UNITED STATES
DEPARTMENT OF THE INTERIOR
BUREAU OF LAND MANAGEMENTFORM APPROVED
OMB NO. 1004-0137
Expires: January 31, 2018**SUNDRY NOTICES AND REPORTS ON WELLS**
Do not use this form for proposals to drill or to re-enter an abandoned well. Use form 3160-3 (APD) for such proposals.5. Lease Serial No.
NMNM76857

8. Well Name and No.
GINNY CORBETT 19. API Well No.
30-045-27125-00-S110. Field and Pool or Exploratory Area
BISTI

Plug and Abandonment Procedure
for
DJR Operating, LLC
Ginny Corbett # 1
API # 30-045-27125
NW/SE, Unit J, Sec. 31, T25N, R11W
San Juan County, NM

BLM FLUID MINERALS Geologic Report

Proposed Wellbore Diagram

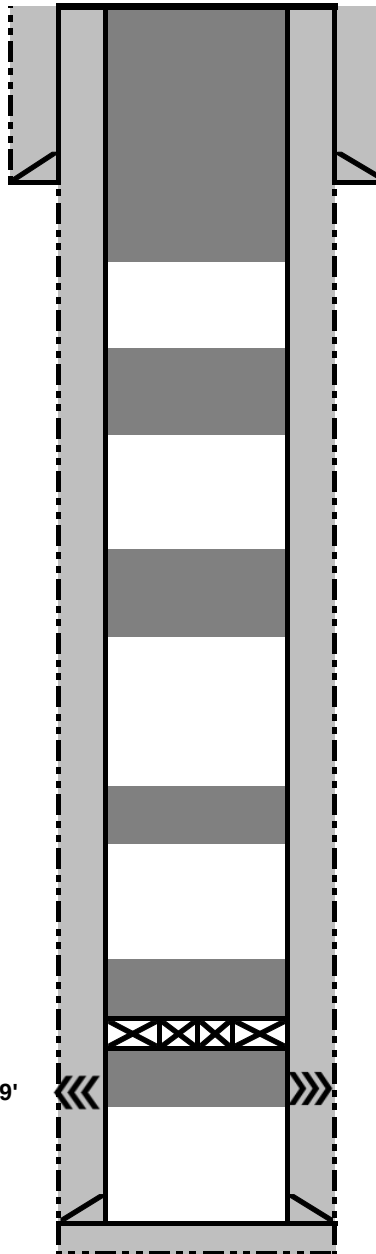
- BLM geologist's formation top pick varies from operator pick for the Kirtland, Mancos, and Gallup formations. The proposed surface plug adequately covers both picks for the Kirtland formation.

- The Mancos plug will need to be adjusted to cover BLM formation top pick @ 3745'.

- The Gallup plug will need to be adjusted to cover BLM formation top pick @ 4658'.

1. Plugging operations authorized are subject to the attached "General Requirements for Permanent Abandonment of Wells on Federal and Indian Lease."
2. Farmington Office is to be notified at least 24 hours before the plugging operations commence (505) 564-7750.
3. The Mancos plug will need to be adjusted to cover BLM formation top pick @ 3745'. Modify plug to cover 3695 to 3795'.
4. The Gallup plug will need to be adjusted to cover BLM formation top pick @ 4658'. Modify plug to cover 4608 to CR at 4750'.
